Subject: Supporting Documents to Registration Certificate NR-655-D-101-S

Subject: Application for Device Registration Certificate Amendment
and Materials License Amendment

Please amend the reference (a) Registration Certificate for the
United Technologies Research Center (UTRC) LTG1 Layer Thickness Gage
to include the changes listed below.

ANSI TEST RESULTS
DUPONT NER 8430 SOURCE

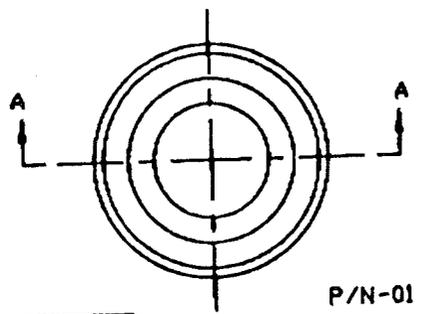
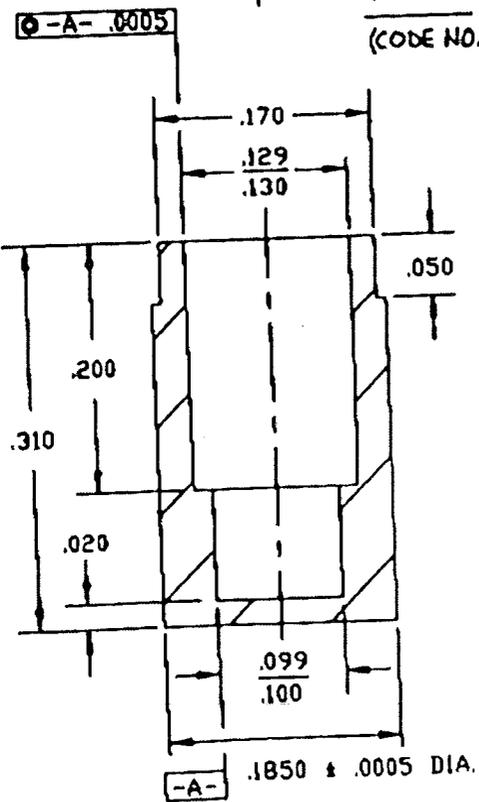
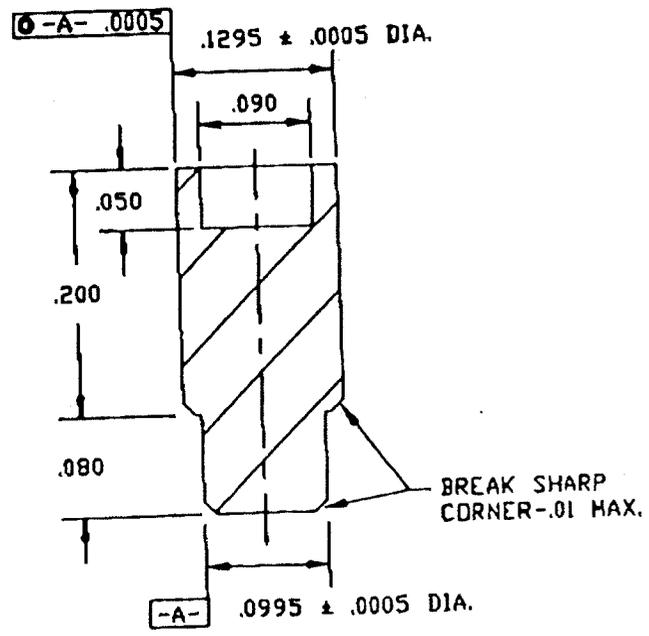
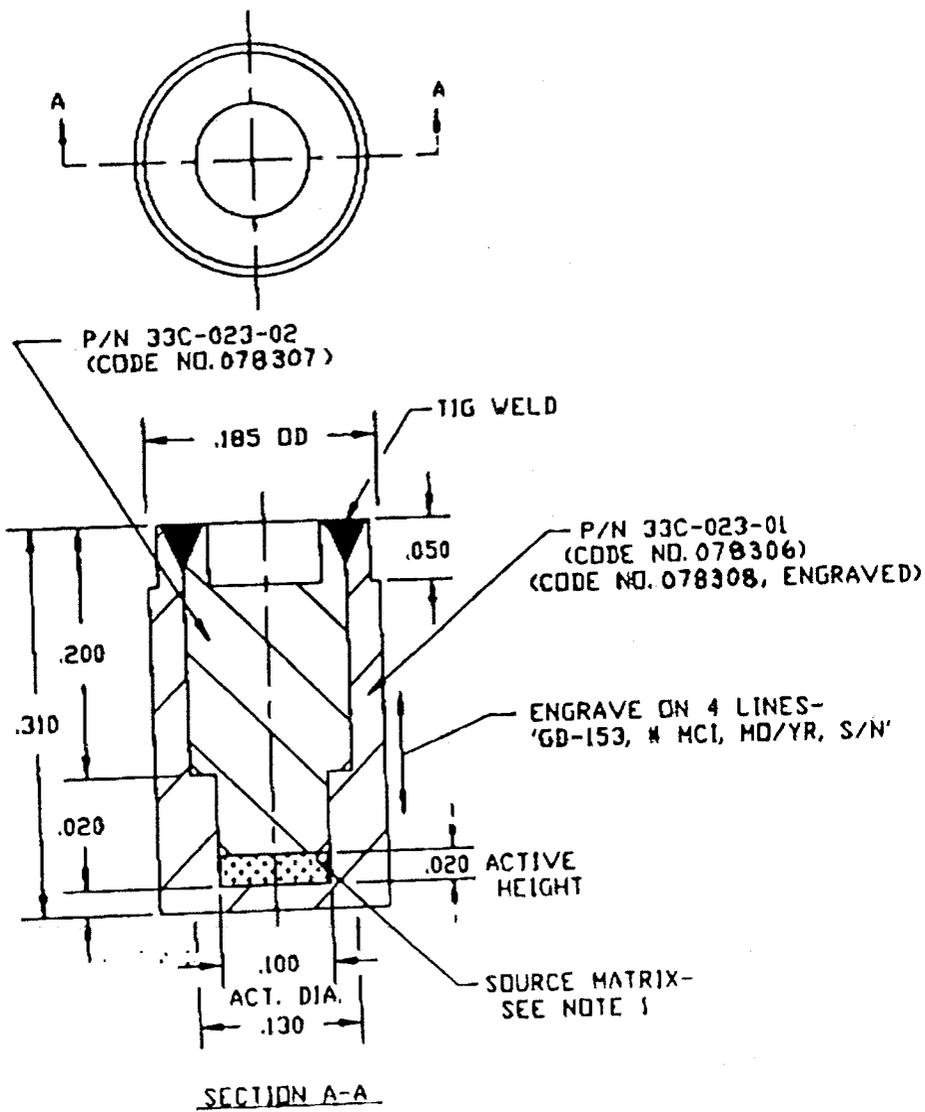
Add two additional sealed source designations so that the Gadolinium-
153 sealed source capsule used in the LTG1 can be any one of the
three listed below (i.e., add sources B and C):

C. Model NER 8430

Currently, these three vendors supply sealed sources to UTRC specifications for Layer Thickness gaging applications. In two cases (GNI and Isotope Products), UTRC fabricates the two-piece, 316 stainless steel capsule for the vendor; DuPont fabricates its own capsules. The vendors load the Gadolinium-153 pellet into the capsule and seal it by welding. DuPont has completed the ANSI testing of its source and is in the process of registering it with NRC; the source successfully passed the C63232 testing. Isotope Products has submitted the previous GNI ANSI test data for registration of its source in California. Details of construction and test data for the DuPont NER 8430 source are included in Enclosure A.

Approximately 0.5mCi ¹⁵³Gd Cl₃ was deposited into each of two test sources and dried onto glass fiber filler paper. The capsules were then assembled and T.I.G. welded per Du Pont dwg #33A-043. The sources were then cleaned and leak tested per ANSI Std N542-1977 procedures A2.2.1 and A2.1.3.
